STATE OF NORTH CAROLINA
DEPARTMENT OF TRANSPORTATION

SUBJECT: **Permit Modification Request for TIP I-2511CB**, I-85 Improvements from North of SR 1002 to North of SR 2120 Near the Town of Spencer in Rowan County, State Project No. 8.1631503, Tip No. I-2511CB. Debit \$475 for Major WQC modification from WBS Element No. 34163.1.1.

REFERENCE: Individual Permit issued October 7, 2004; USACE Action ID 200221534 NC WQC No. 3456 issued April 20, 2004 (Modified January 7, 2005); DWQ Project No. 040271.

Site 7A, Sheet 24 of 35

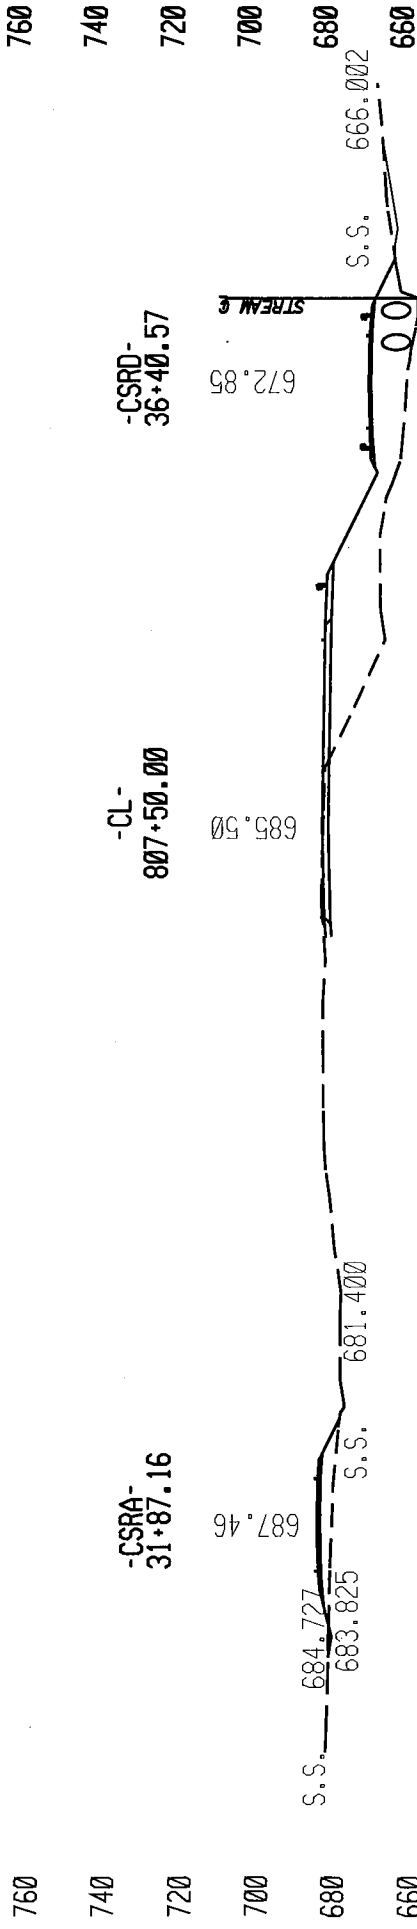
Extend existing RCP in UT to Town Creek. Original Permanent Impact: 271 linear feet; New Permanent Impact: 162 linear feet.

Impact change: Permanent stream impact = decrease of 109 linear feet (of which 41 linear feet originally required mitigation)
Temporary stream impact = 10 linear feet

Site 7B, Sheet 26 of 35

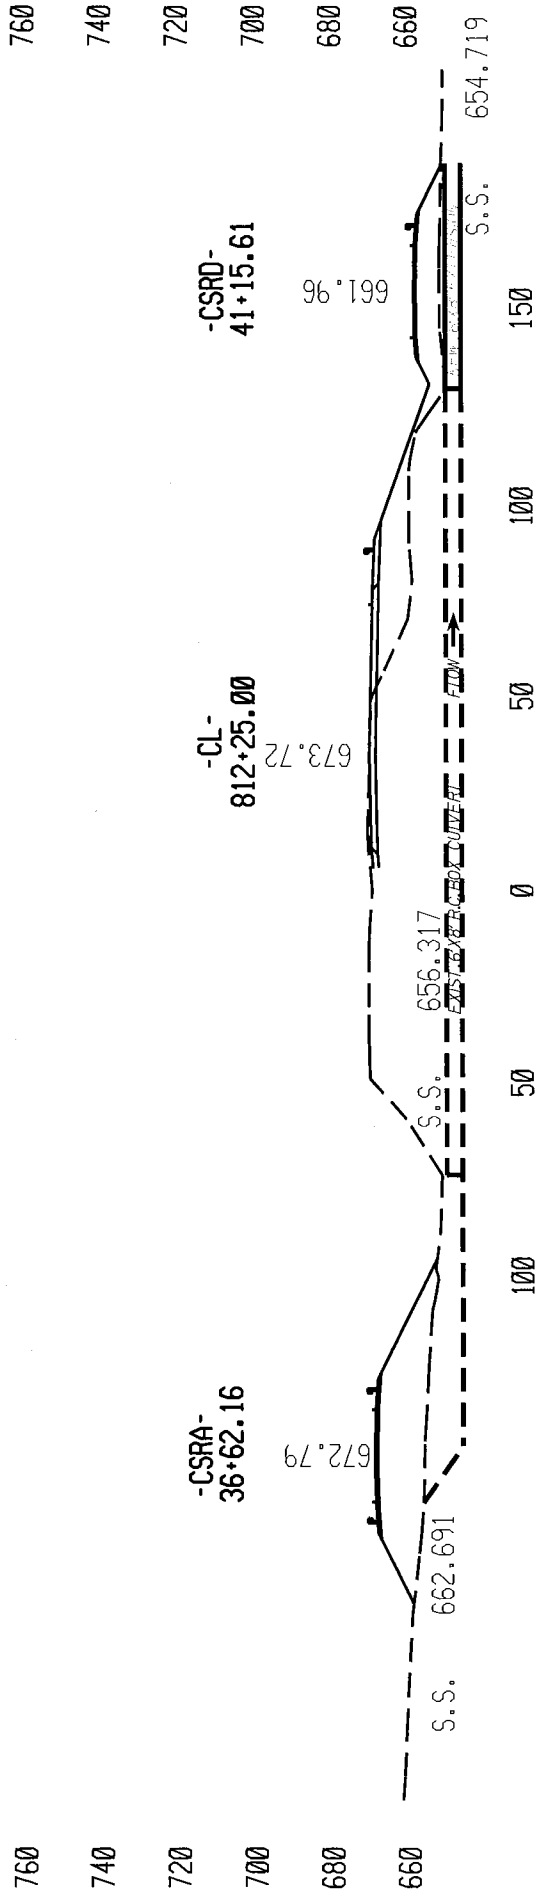
Extend existing RCBC in UT to Town Creek. Original Permanent Impact: 210 linear feet; New Permanent Impact: 200 linear feet.

Impact change: Permanent stream impact = decrease of 10 linear feet (originally required mitigation)
Temporary stream impact = 30 linear feet

Site 8, Sheet 28 of 35

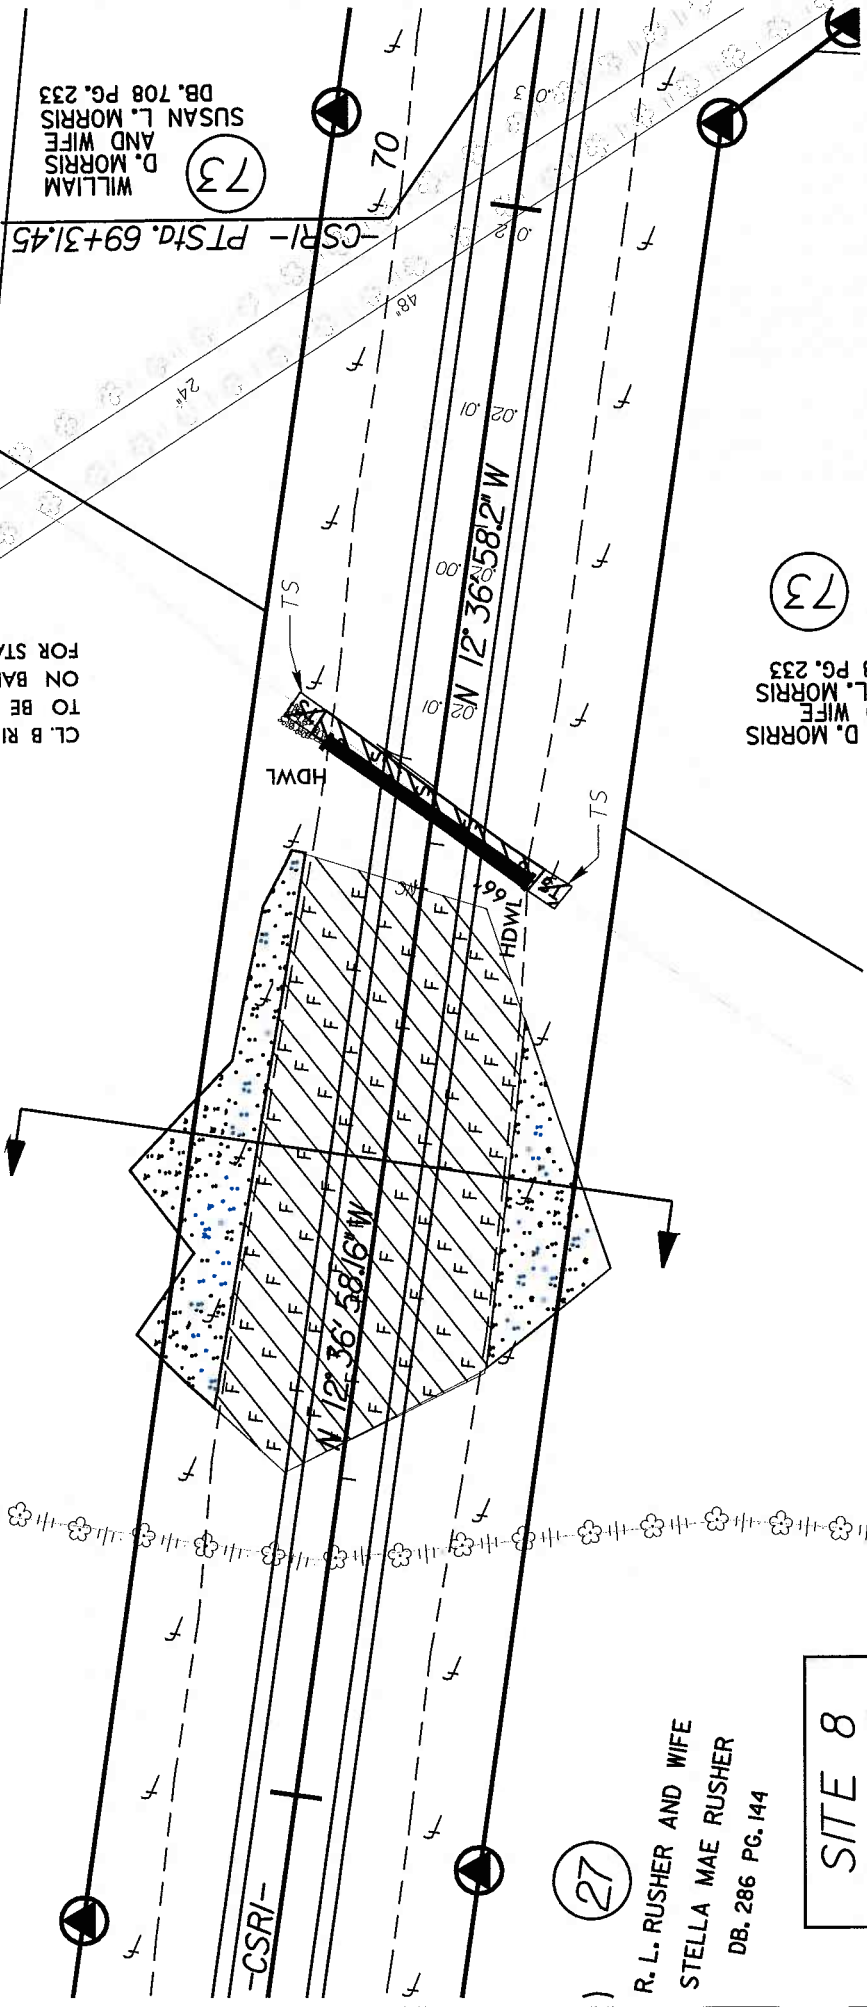
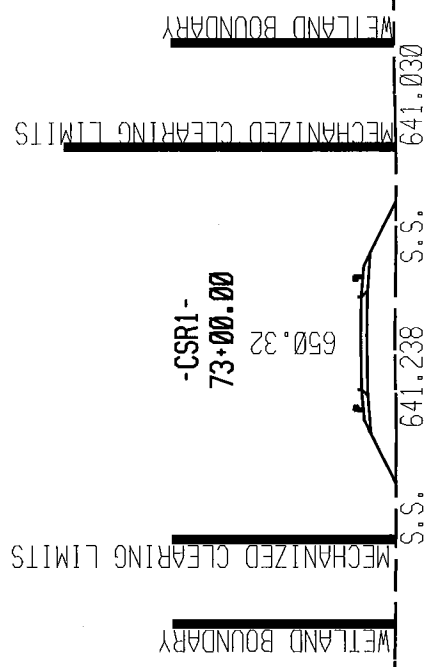
Placement of RCP in UT to Town Creek, placement of clean fill material and mechanized clearing in non-riverine wetland. Original Permanent Stream Impact: 90 linear feet; New Permanent Stream Impact: 85 linear feet. Original Permanent Wetland Impact: 0.47-acre; New Permanent Wetland Impact: 0.47-acre.

Impact change: Permanent stream impact = decrease of 5 linear feet (no change in mitigation requirements)
Temporary stream impact = 20 linear feet
Permanent wetland impact = no change

Site 10, Sheet 32 of 35

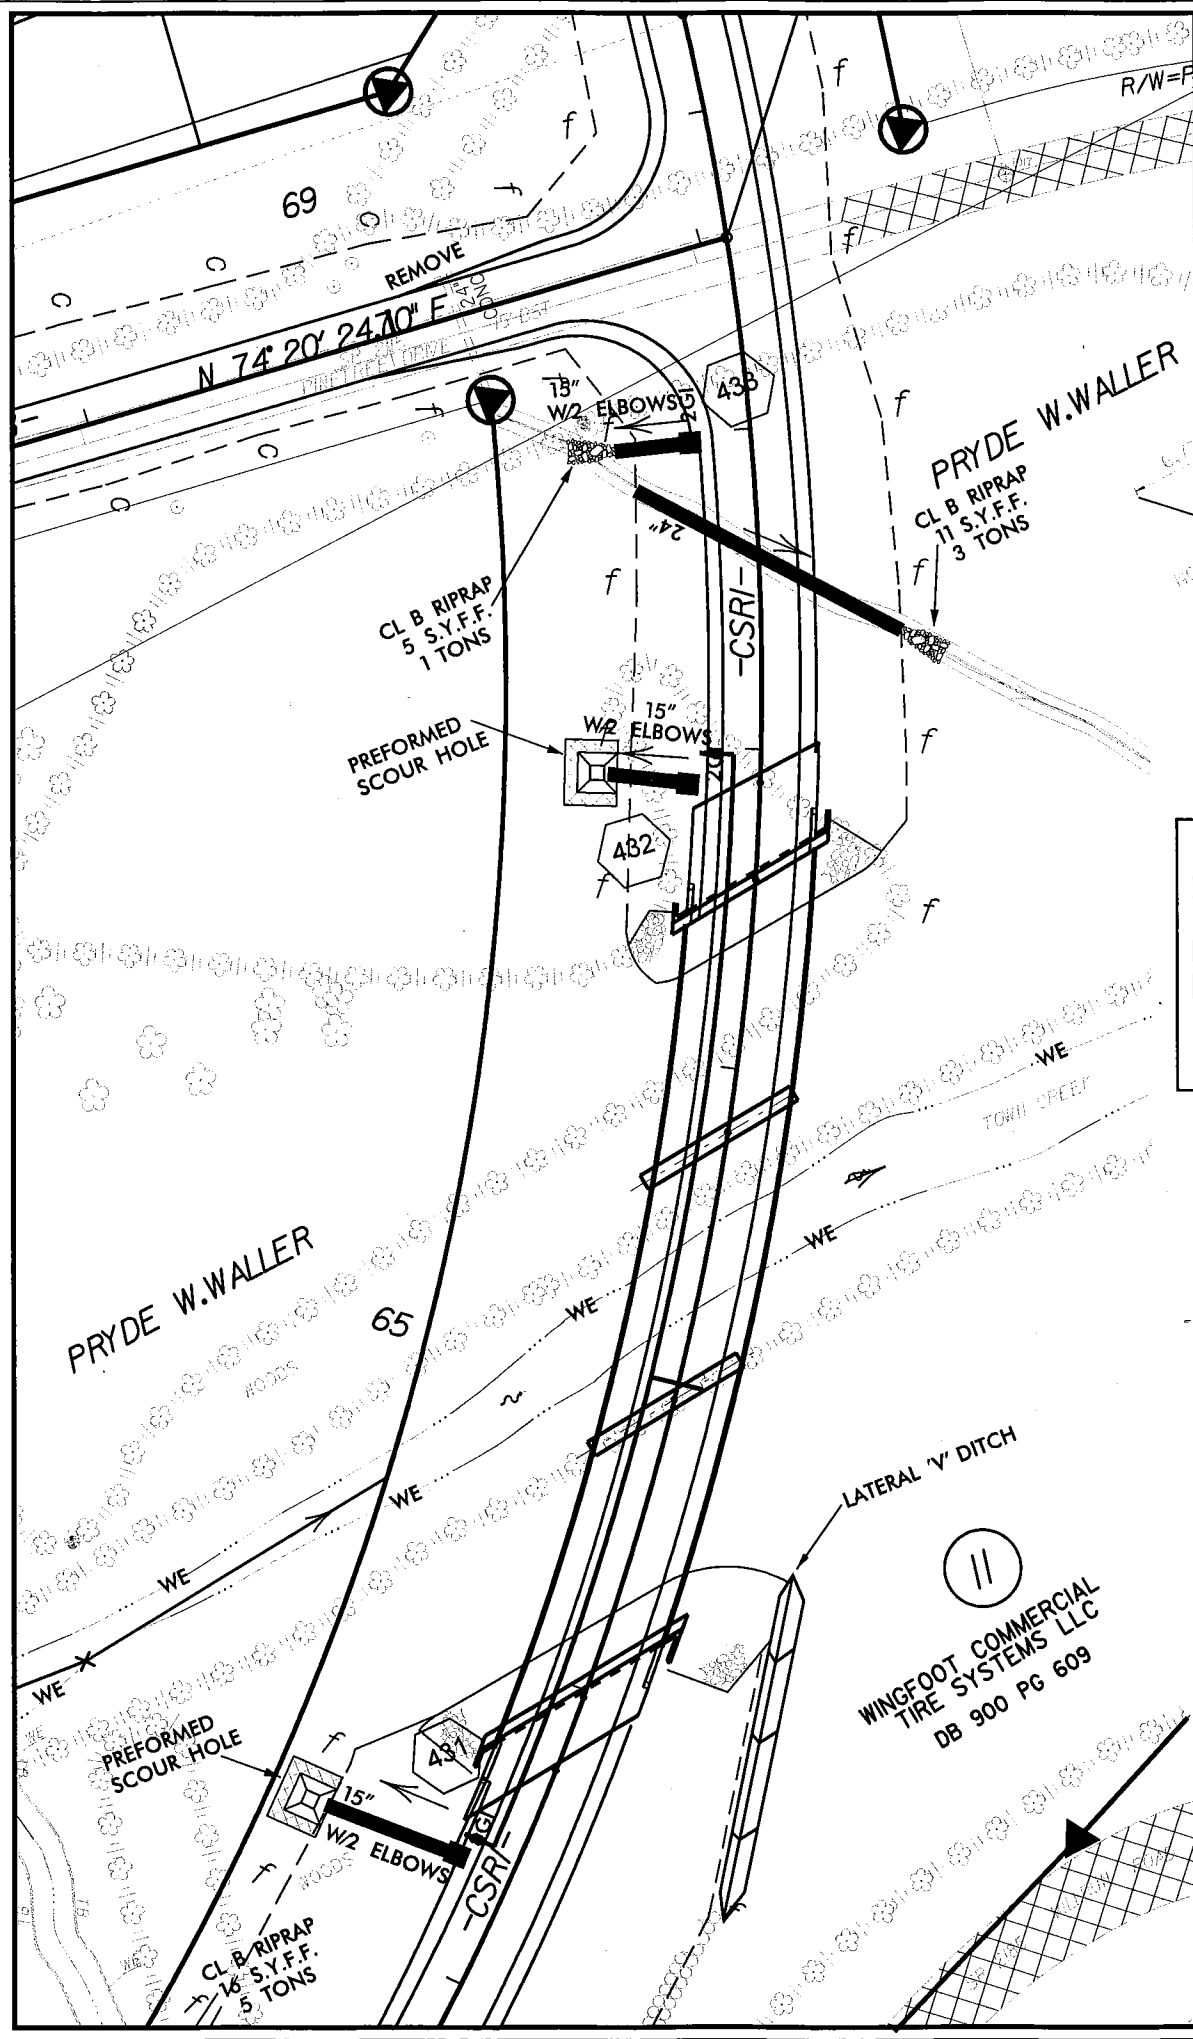
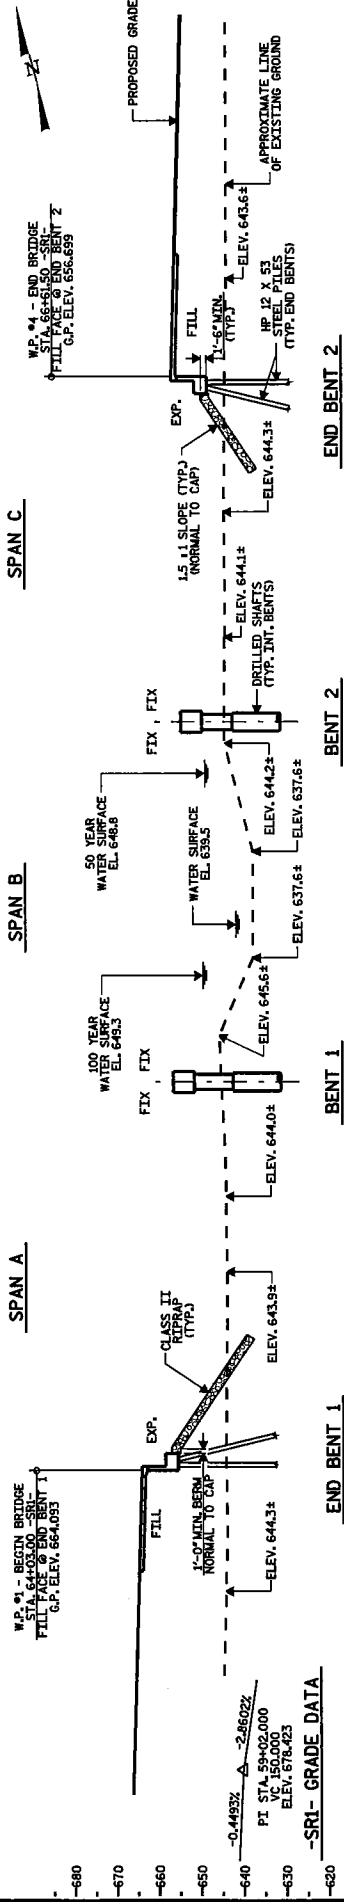
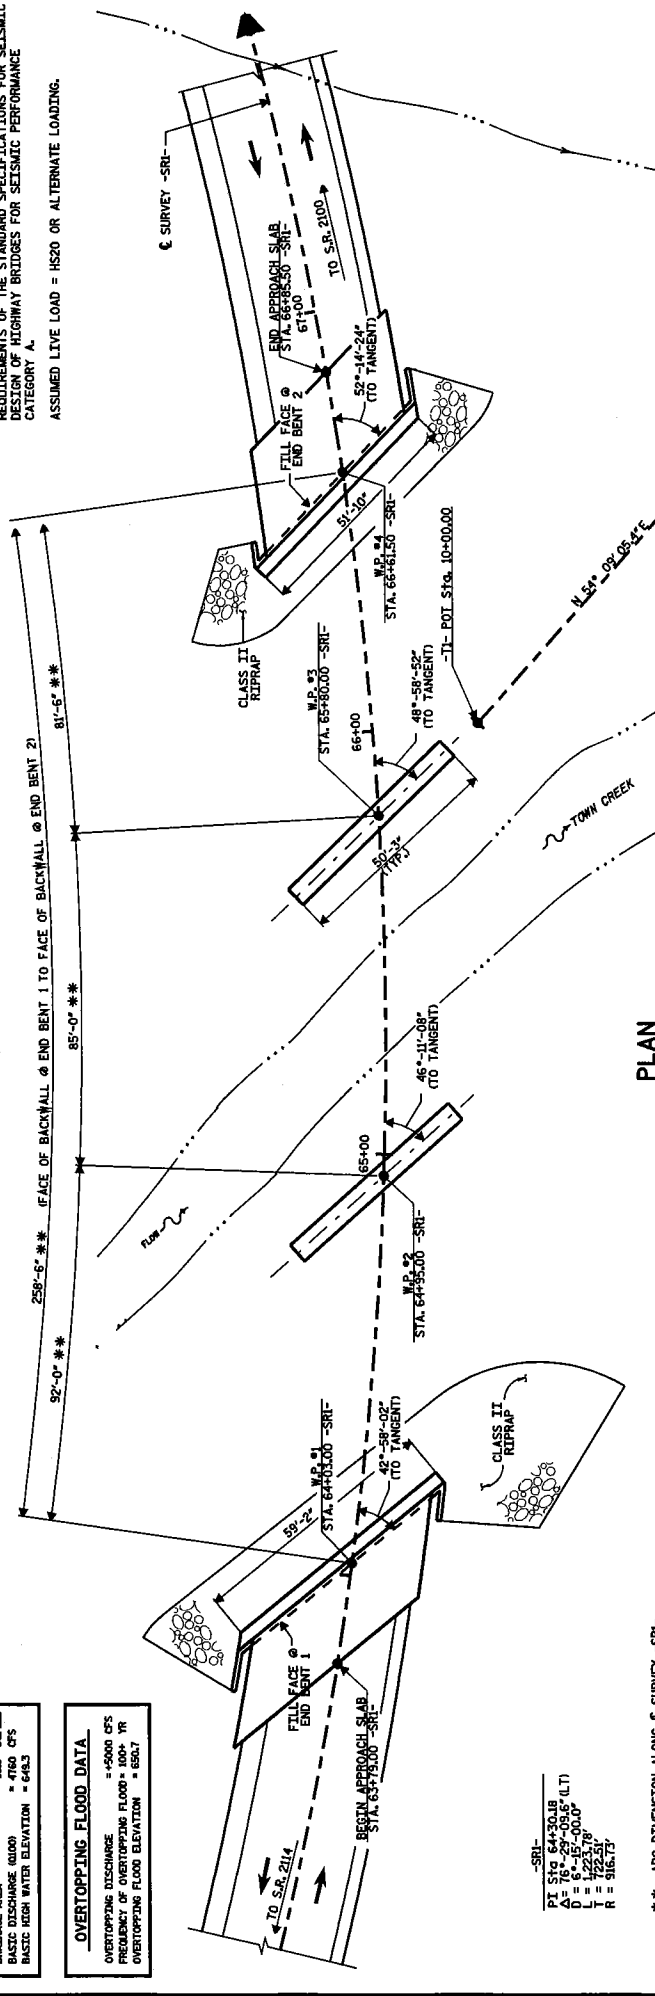
Construction of a 3-span bridge over Town Creek. Original Permanent Impact: 0 linear feet; New Permanent Impact: 0 linear feet.

Impact change: Permanent stream impact = no change

Site 9, Sheets 30 and 31 of 35

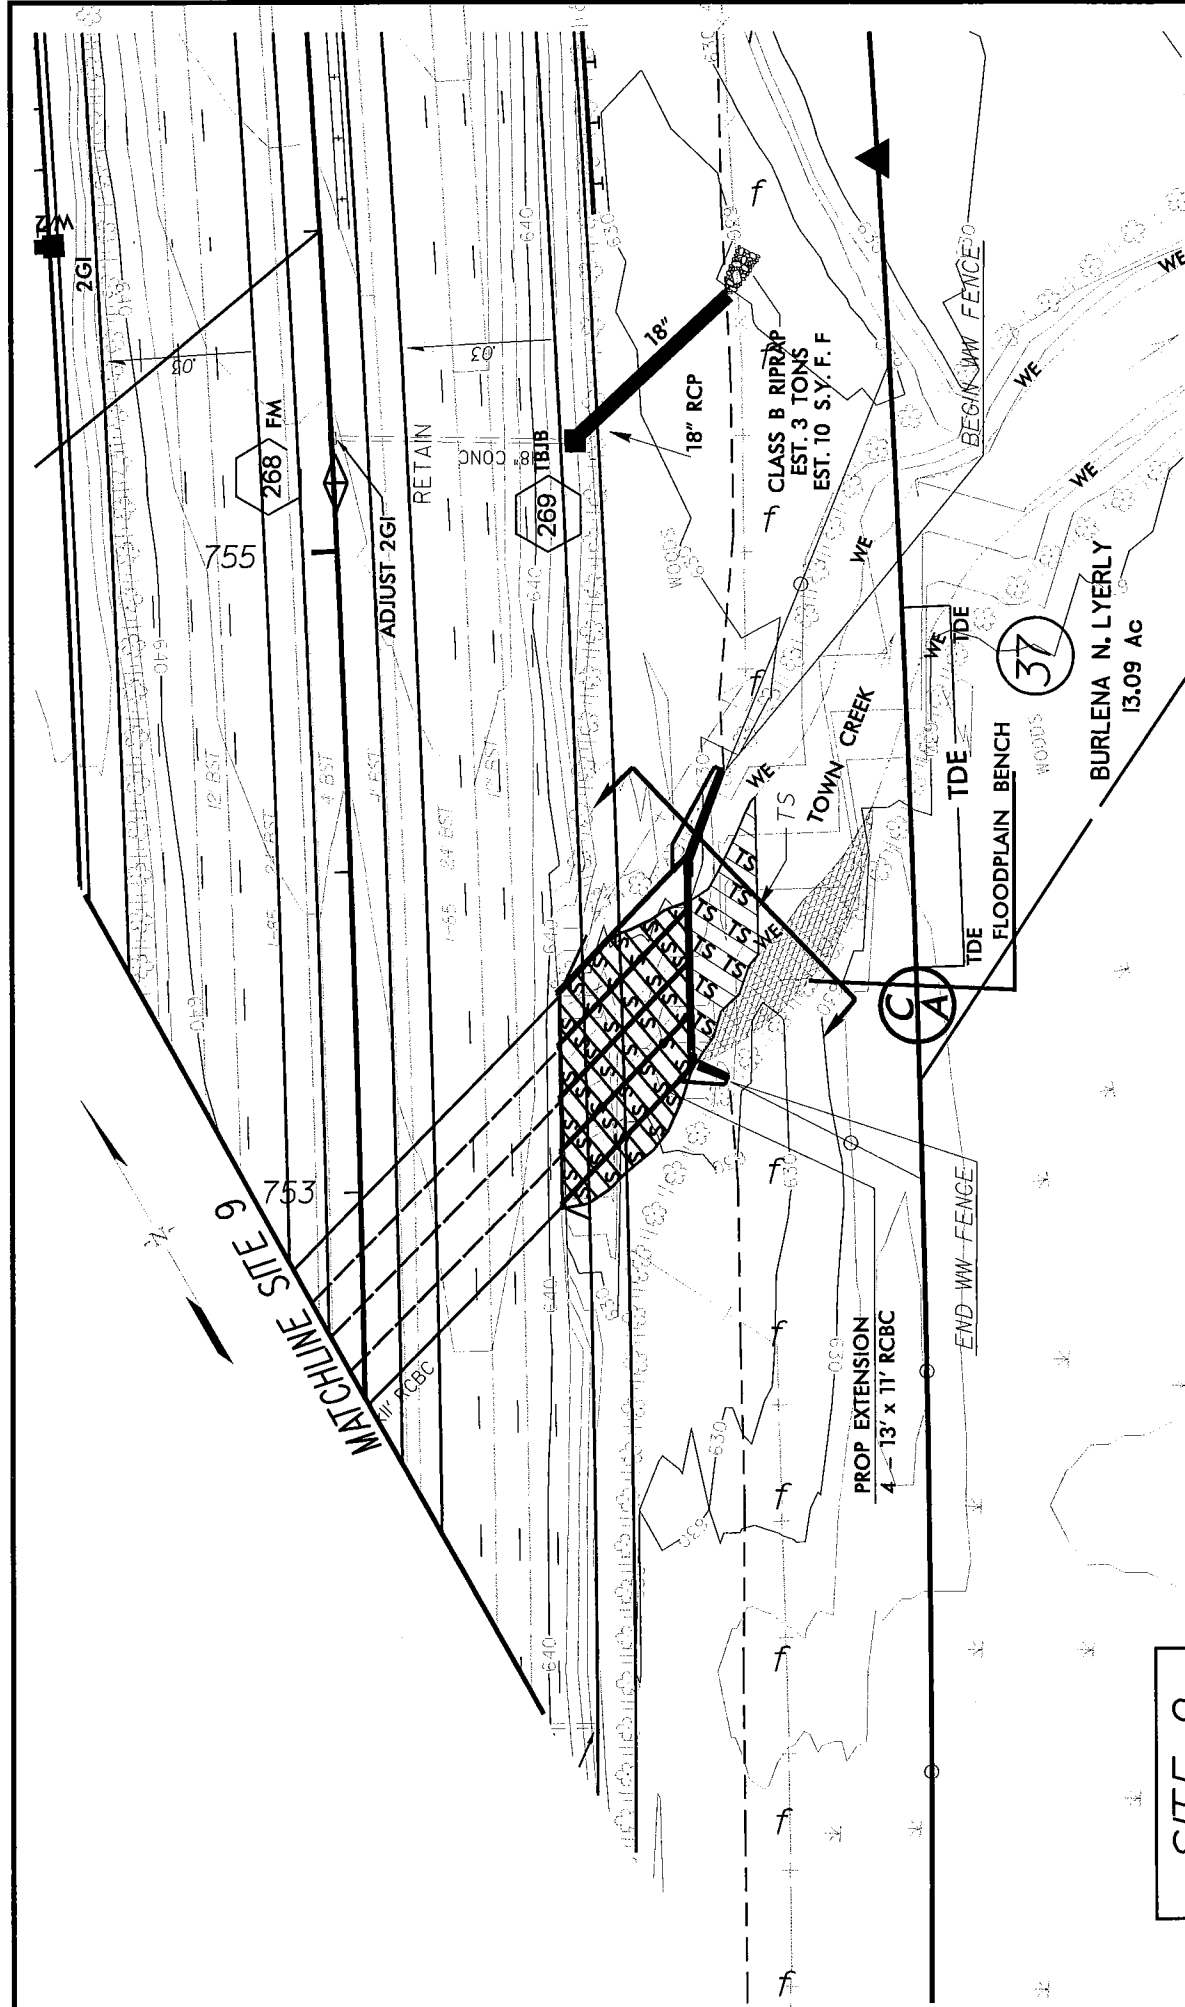
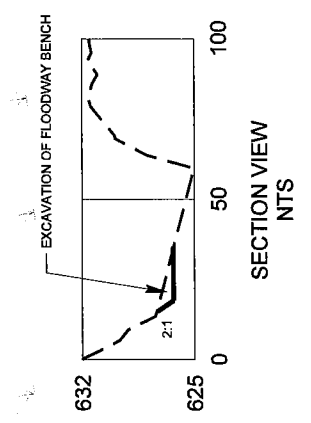
Extend existing RCBC in Town Creek. Floodplain benches are proposed on either side of the stream channel to accommodate the headwalls associated with the RCBC. These would be excavated entirely in uplands and would not impact the stream channel. Original Permanent Impact: 130 linear feet; New Permanent Impact: 114 linear feet.

Impact change: Permanent stream impact = decrease of 16 linear feet (which originally required mitigation)
Temporary stream impact = 40 linear feet
